## **STANDARD FIELD SERVICE BULLETIN**

FSB Number	CHRAEFSB2015-47
Author	Rajesh Verma
Date	07/20/2015
Subject	Moto G (3rd Generation) - Camera Picture Quality
Model Affected	XT1540/XT1541/XT1542/XT1543/XT1544/XT1548/XT1549/ XT1550/XT1551/XT1552
Level Of Repairs	Level 2

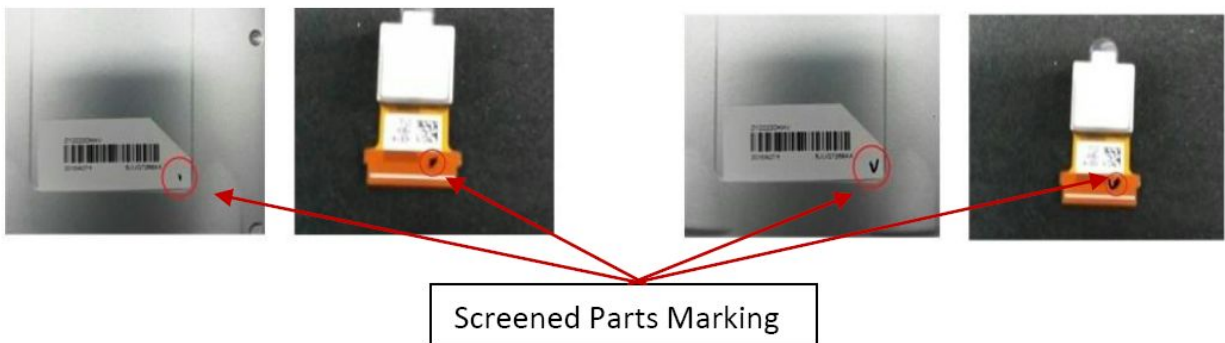
Motorola is aware of a potential field return issue on Moto G 3<sup>rd</sup> Gen product related to Camera picture quality. Photos taken with Moto G 3<sup>rd</sup> Gen under certain lighting conditions or at certain angles may show slight pink hue or in some cases increase red in center as shown below in example Photos.

Engineering analysis root caused this issue to a Camera module supplier manufacturing process issue where some out of specifications filters were used.

**Screened Part Markings:** Screened parts at manufacturing locations have been marked with “dot” or “V” marking on the Camera module as shown above.

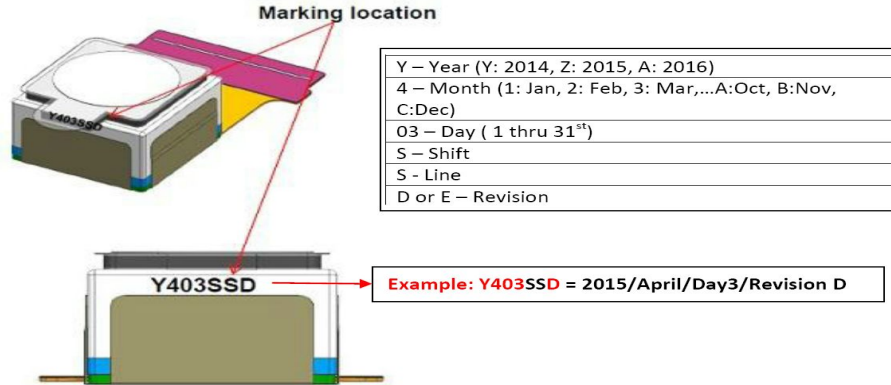
1. Starting July 11, 2015, the camera imager suppliers and manufacturing locations have implemented screening process to capture affected phones that were built with suspected out of specification parts.

**New parts Good Date Code Markings: Z711xxD / Z711xxE and later (Date Codes after July 11, 2015 have been marked for screened parts)**

- b. Following Service Manual, carefully disassemble the phone to gain access to the Rear Camera module (P/N: 0101836700xW).
  - c. Replace Rear Camera Module (P/N: 0101836700xW) with a known good part date coded Z711xxD / Z711xxE and later. Refer to images provided above.

For Rear Camera Module (P/N: 0101836700xW), Use and Stock only parts that are either marked as screened (blue triangle on the box) or have a date code marking Z711xxD / Z711xxE and later.
